Contract #: 04-0120F4Cty: SF/ALA Rte: 80 PM: 13.2/13.9File #: 69.25B**QUALITY ASSURANCE -- NON-CONFORMANCE REPORT****Location:** Changxing Island, Shanghai, P.R. China**Report No:** NCR-000833**Prime Contractor:** American Bridge/Fluor Enterprises, a JV**Date:** 04-Sep-2010**Submitting Contractor:** Zhenhua Port Machinery Company, Ltd (ZPMC), Changxing Island**NCR #:** ZPMC-0795**Type of problem:**

**Reference Description:** Missed UT Indication located at 99m Cross Bracing Gusset Plate**Description of Non-Conformance:**

**Subject:** NCR No. ZPMC-0795

This weld is identified as WD1-GUSA3-3-99M-W#4B.

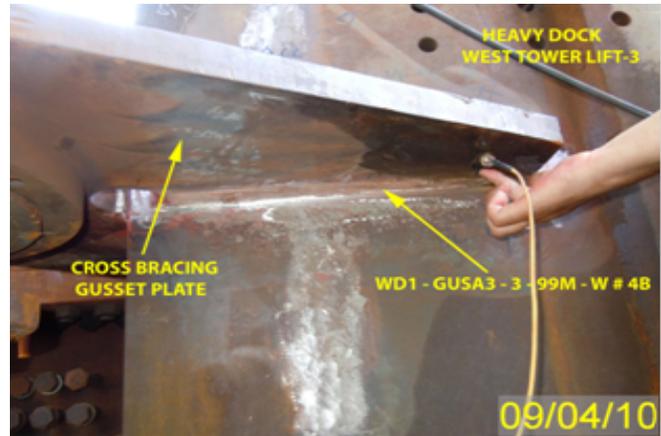
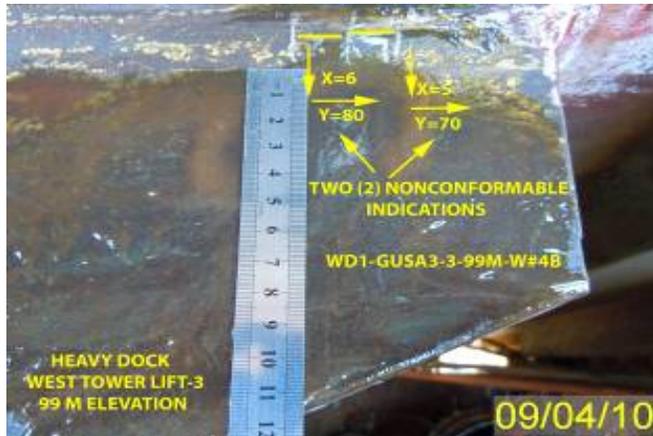
During random 10% verification Ultrasonic Testing (UT) of Cross Bracing Gusset plate, this Quality Assurance Inspector (QA) discovered the following issues:

- Two (2) Class "A" non conforming longitudinal indication's in one weld.
- First UT discontinuity rating was -2 db; Class "A" non-conforming indication.

- Depth of the discontinuity from face "B" is approximately 18mm.

- Length of the discontinuity is approximately 15mm.

location is 70 mm from Skin D/E corner of the weld.

- Second UT discontinuity rating was +0 db; Class "A" non-conforming indication.
- Depth of the discontinuity from face "B" is approximately 24mm.

- Length of the discontinuity is approximately is 10mm.
- Y location is 80 mm from Skin D/E corner of the weld.

- This weld is a T-joint complete joint penetration (CJP), between the West Tower Skin 'E' and the Cross Bracing Gusset plate.

- Scanning was performed from face "B" using 2.25 MHz, 3/8 inch transducer to cover the full volumetric scan of the weld.

**Reference Resolution:** ZPMC has repaired the missed indication and is providing the WRR and NDT performed after the repair to show the weld is acceptable.

This proposed resolution is acceptable. The documentation received is sufficient and the Department concurs that Non-Conformance ZPMC-0795 is closed.

This weld is identified as WD1-GUSA3-3-99M-W#4B.

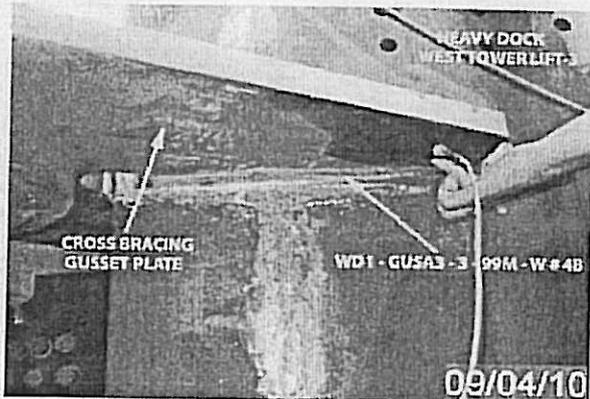
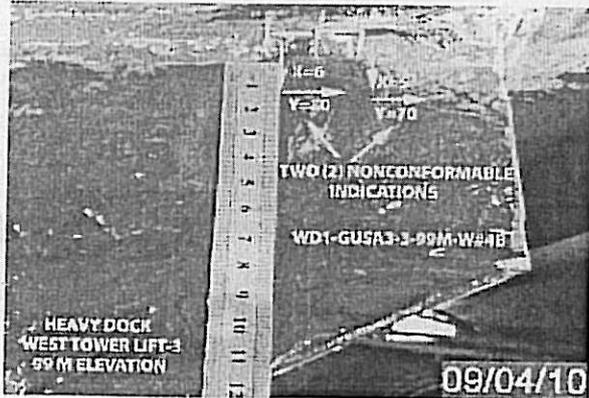
During random 10% verification Ultrasonic Testing (UT) of Cross Bracing Gusset plate, this Quality Assurance Inspector (QA) discovered the following issues:

- Two (2) Class "A" non conforming longitudinal indication's in one weld.
- First UT discontinuity rating was -2 db; Class "A" non-conforming indication.

-Depth of the discontinuity from face "B" is approximately 18mm.

-Length of the discontinuity is approximately 15mm.

location is 70 mm from Skin D/E corner of the weld.

-Second UT discontinuity rating was +0 db; Class "A" non-conforming indication.

-Depth of the discontinuity from face "B" is approximately 24mm.

-Length of the discontinuity is approximately is 10mm.

-Y location is 80 mm from Skin D/E corner of the weld.

-This weld is a T-joint complete joint penetration (CJP), between the West Tower Skin 'E' and the Cross Bracing Gusset plate.

-Scanning was performed from face "B" using 2.25 MHz, 3/8 inch transducer to cover the full volumetric scan of the weld.

焊缝编号为：WD1-GUSA3-3-99M-W-4A/B

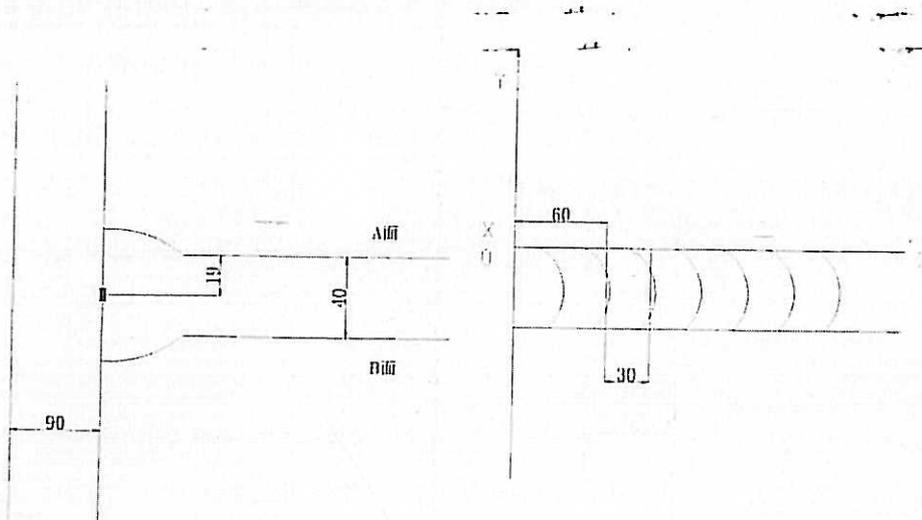
焊缝缺陷描述：(普通UT探伤发现的缺陷长度小于最大允许长度)  
( Description of welding discontinuity )

1. 焊道未及时处理干净。
1. Did not clear the weld pass completely in time.

1. 从缺陷距离端面较近一侧 ( $D \leq 0.65T$ , D为缺陷深度, T为板厚) 采用碳刨或打磨的方法去除焊缝缺陷;
  2. 参照返修焊接工艺规程 (WPS) 准备正确的接头型式, 预热和焊接;
  3. 将修补区域打磨到与母材或邻近焊缝平齐;
  4. 根据批准的车间图纸检查焊缝.
- 
1. Gouge or grind from nearer side from metal edge ( $D \leq 0.65T$ , "D" is depth of defects, "T" is thickness of metal) to remove all defects;
  2. Follow repair WPS for joint preparation, preheat, and weld deposit;
  3. Grind the repaired area flush with base metal or the adjacent weld;
  4. Check the welds according to the working drawings.
